SAN ONOFRE NUCLEAR GENERATING STATION, UNIT NO. 3

AMENDMENT TO FACILITY OPERATING LICENSE

Amendment No. 71
License No. NPF-15

ATTACHMENT TO LICENSE AMENDMENT NO. 71

FIGURE 3.4-2

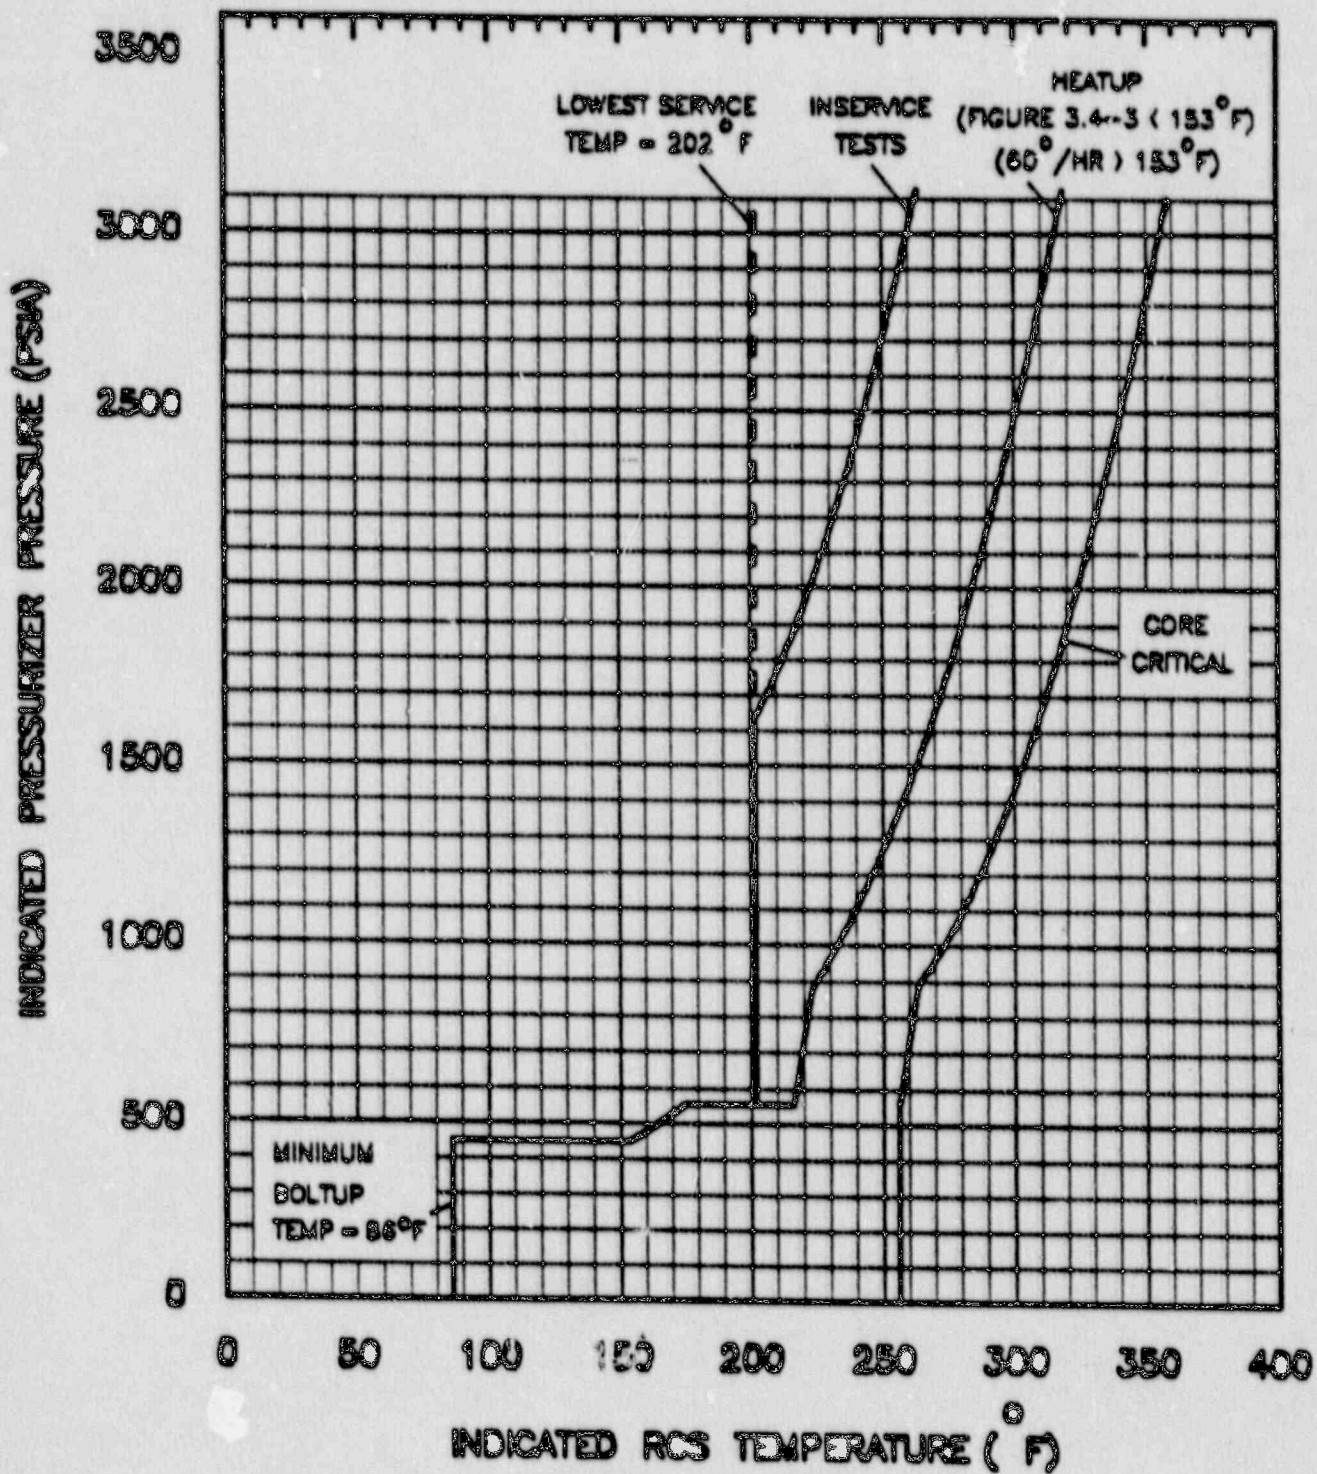
The heatup and cooldown limit curves (Figures 3.4-2 and 3.4-3) are composite curves which were prepared by determining the most conservative case, with either the inside or outside wall controlling, for any heatup rate of up to 60°F/hr or cooldown rate of up to 100°F/hr. The heatup and cooldown curves were prepared based upon the most limiting value of the predicted adjusted reference temperature at the end of the service period indicated on Figures 3.4-2 and 3.4-3.

The pressure-temperature limit lines shown on Figures 3.4-2 and 3.4-3 for reactor criticality and for inservice leak and hydrostatic testing have been provided to assure compliance with the minimum temperature requirements of Appendix G to 10 CFR 50.

FIGURE 3.4-3

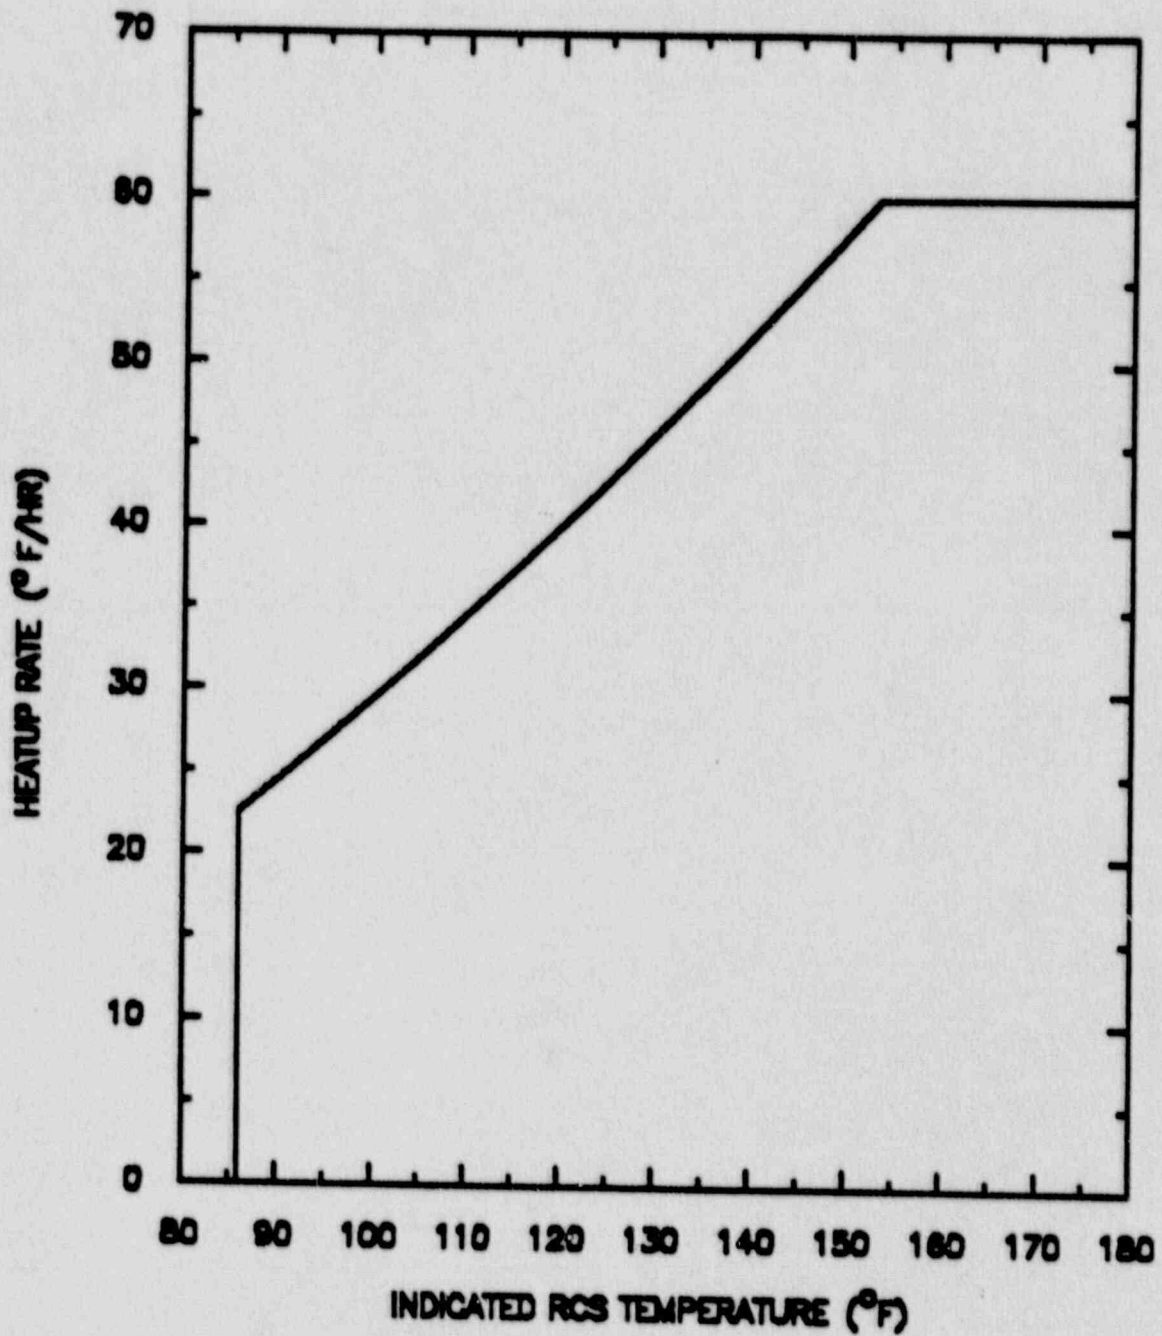
- a. A maximum heatup as specified by Figure 3.4-3 in any 1-hour period with RCS cold leg temperature less than 153°F. A maximum heatup of 60°F in any 1-hour period with RCS cold leg temperature greater than 153°F.
- b. A maximum cooldown as specified by Figure 3.4-5 in any 1-hour period with RCS cold leg temperature less than 126°F. A maximum cooldown of 100°F in any 1-hour period with RCS cold leg temperature greater than 126°F.
- c. A maximum temperature change of 10°F in any 1-hour period during inservice hydrostatic and leak testing operations above the heatup and cooldown limit curves.
- d. A minimum temperature of 86°F to tension reactor vessel head bolts.

NOTE: A MAXIMUM HEATUP RATE OF 80°F/HR IS ALLOWED AT ANY TEMPERATURE ABOVE 153°F

FIGURE 3.4-4

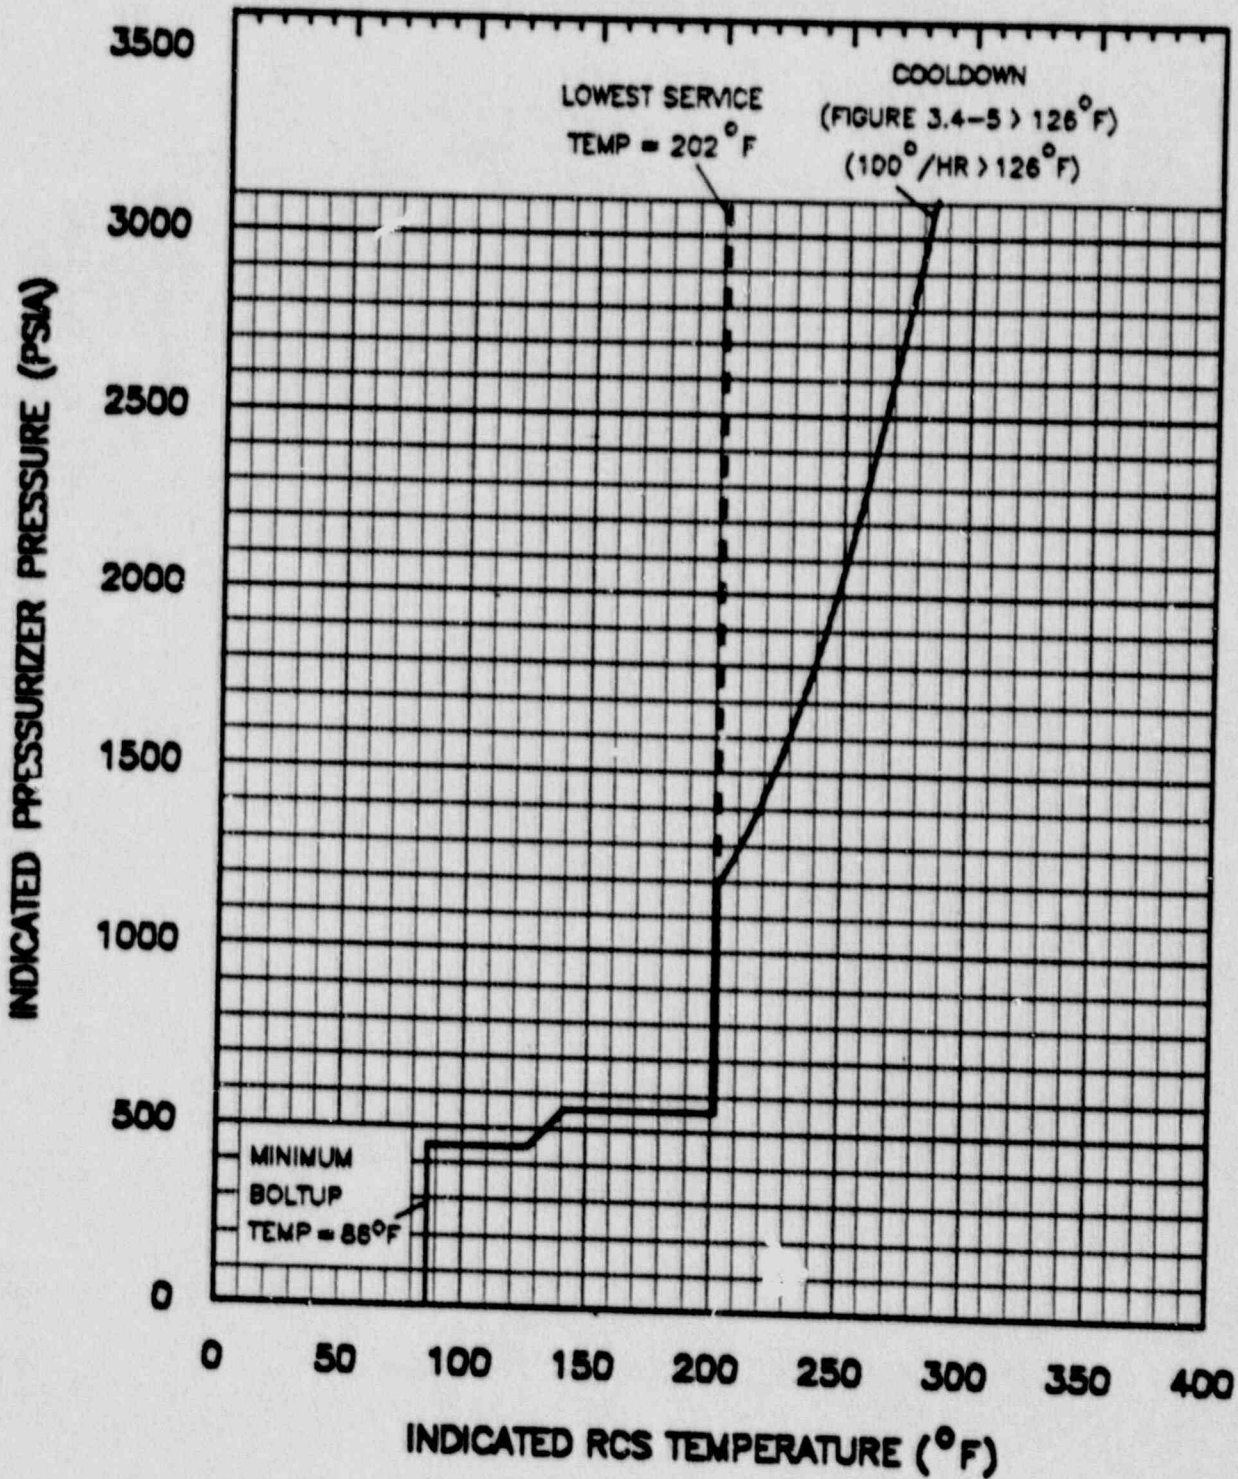
3.4.8.1 With the reactor vessel head bolts tensioned*, the Reactor Coolant System (except the pressurizer) temperature and pressure shall be limited in accordance with the limit lines shown on Figures 3.4-2, 3.4-3, 3.4-4, and 3/4-5 during heatup, cooldown, criticality, and inservice leak and hydrostatic testing with:

FIGURE 3.4-5

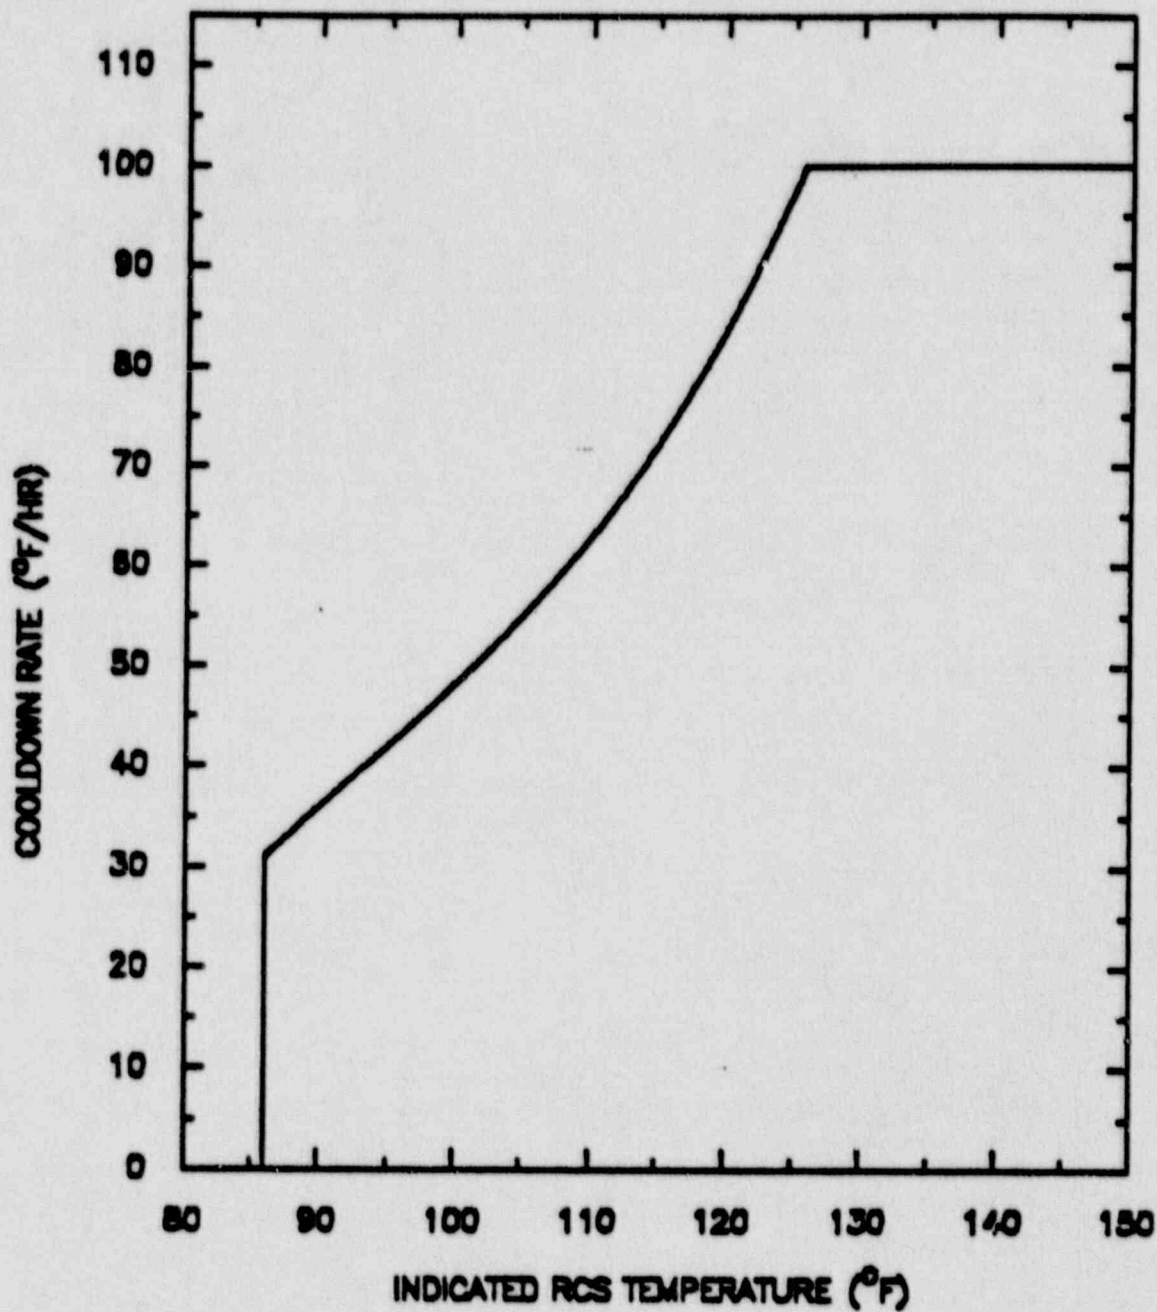
NOTE: A MAXIMUM COOLDOWN RATE OF 100°F/HR IS ALLOWED AT ANY TEMPERATURE ABOVE 128°F
